AA-INFO-FT 03-LU-01

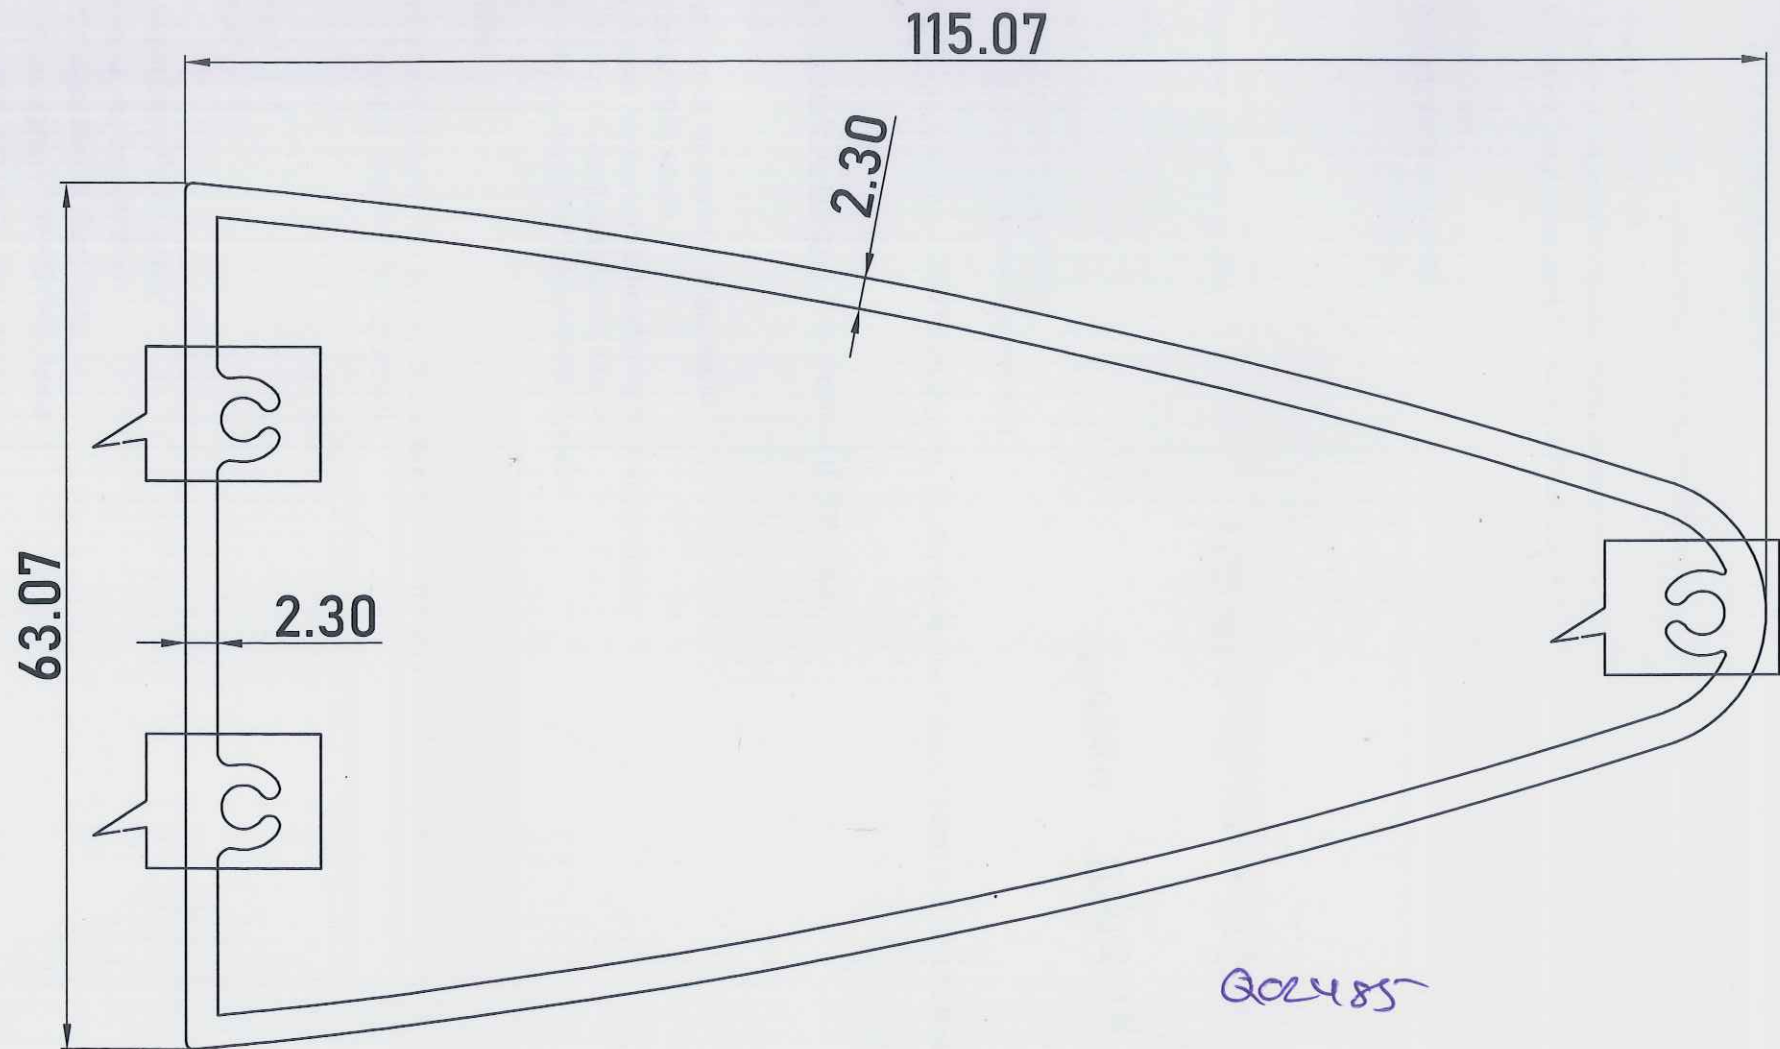
THE SCREW POT SIZE SHOULD BE MATCH
WITH EXISTING DIE S4669
